Errata

Applies to IP65 step motors from pilot production build

Eight lead motor connected in PARALLEL to a bipolar drive.

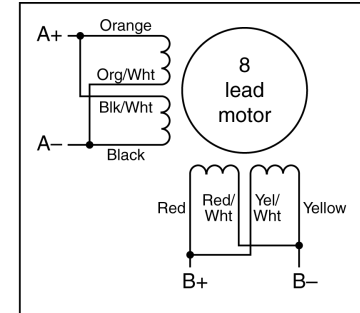
1. Some units have cables that are rated 80°C. These motors should be operated such that the case temperature does not exceed 80°C.
2. The wire colors may differ from our standard. See wiring diagrams below and on the back.

Motors with orange, orange/white, red, red/white, black, black/white, yellow, yellow/white.

Eight lead motor connected in PARALLEL to a bipolar drive.

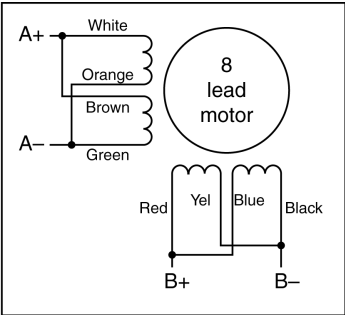
Motors with white, orange, brown, green, red, yellow, blue, black.

Eight lead motor connected in PARALLEL to a bipolar drive.

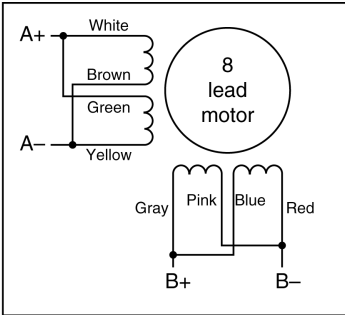
Motors with white, brown, green, yellow, gray, pink, blue, red.
